JARDIM ESTATES EAST

Tarrytown, New York

Date of Acceptance **October 22, 2012**

FINAL ENVIRONMENTAL IMPACT STATEMENT

Figure 1: Alternative Cluster- New Roadway

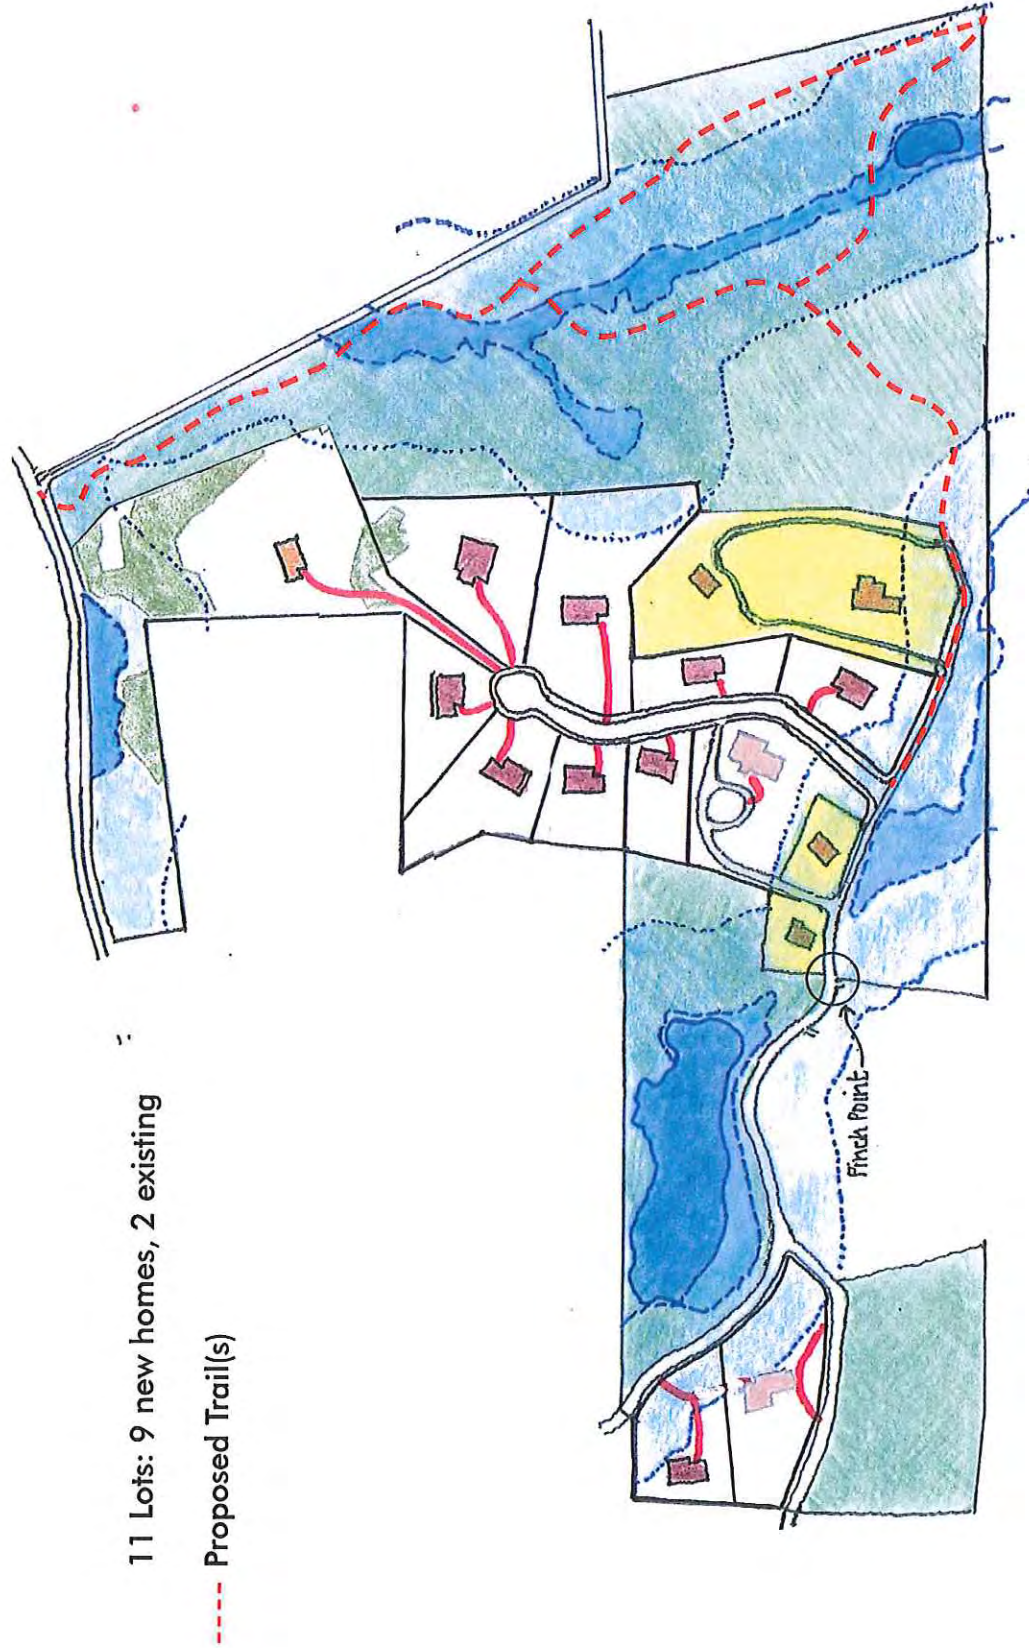
Figures 1 and 2 illustrate two alternative cluster designs. Both cluster alternatives eliminate the two lots with the shared driveway east of the Maselli property and include a new lot on the northern portion of the site with access from the cul-de-sac. Both these alternatives result in an 11 lot subdivision (9 new lots and 2 existing lots) that preserves the sensitive environmental area on the eastern portion of the site. A potential trail system is shown along the eastern portion of the site linking the site to the proposed Greystone 3.9.6

development to the south and Taxter Ridge Park to the north. An east-west trail is also shown along the southern portion of the property. The difference between the two layouts is that Figure 1 provides for a new cul-de-sac roadway, while Figure 2 utilizes the existing Gracemere Avenue to access the new cul-de-sac. The impacts of these two different roadway layouts should be evaluated in the FEIS. 3.9.6
